Collins 4N64W18T doc no. 400785594

COGCC is in the process of reviewing the Form 2A for the Collins 4N64W18T location (doc no. 400785594). In order to complete our evaluation, please address the following:

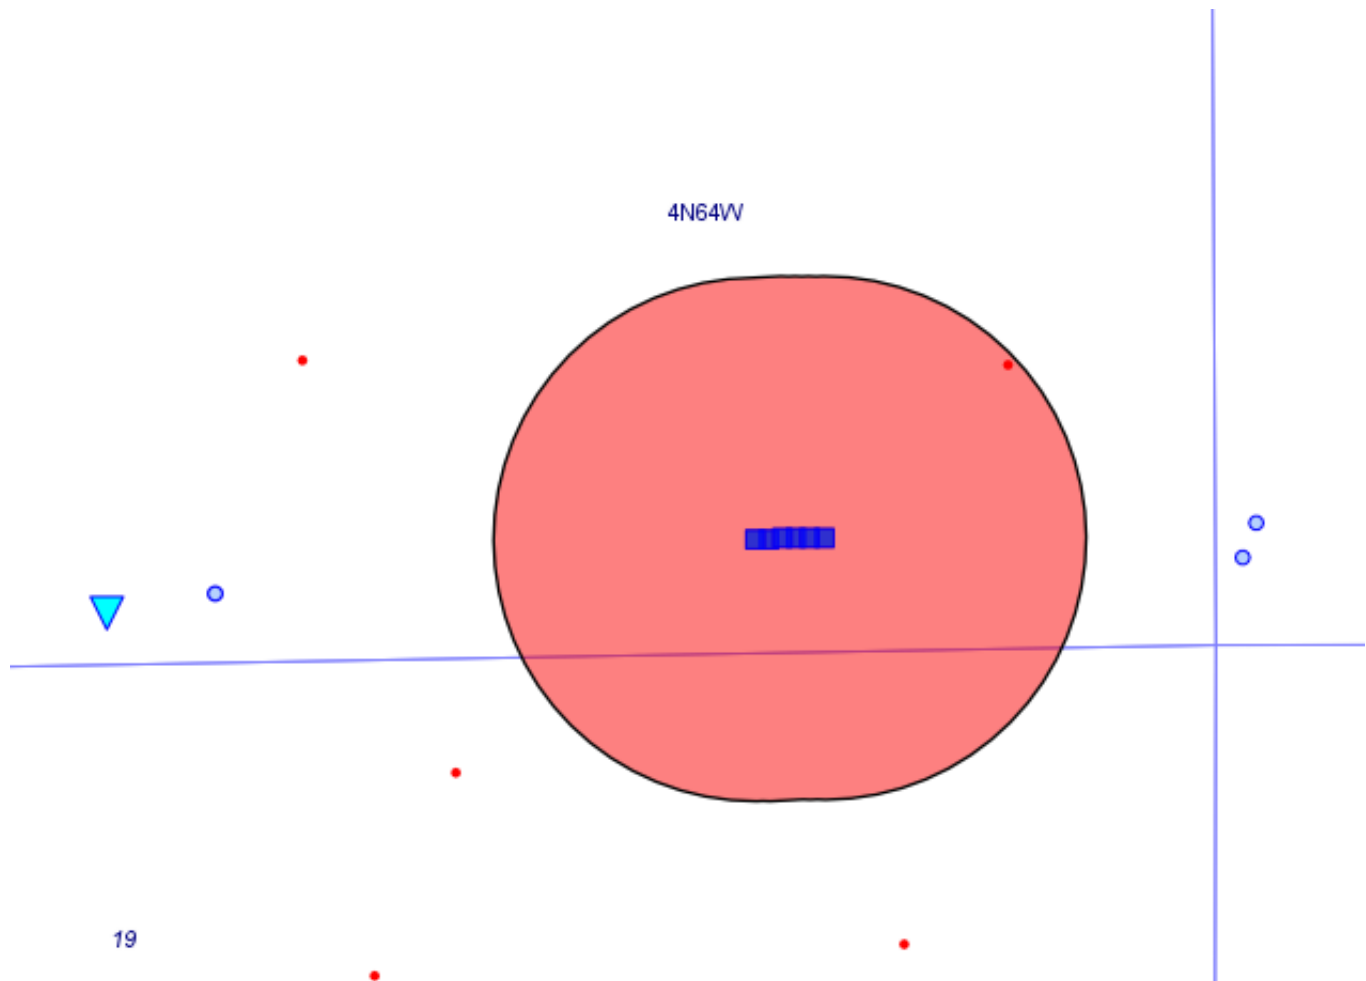
2. The location rational explains the location for the wells, but how was the production location evaluated? Would it be possible to have production on the west side of the wells, out of the buffer zone?

2. If we moved the facility to the other side of the wells we would pull in the building unit to the west there for we would still be in a buffer zone. Attached is a map with 1000' buffers drawn around the BU.
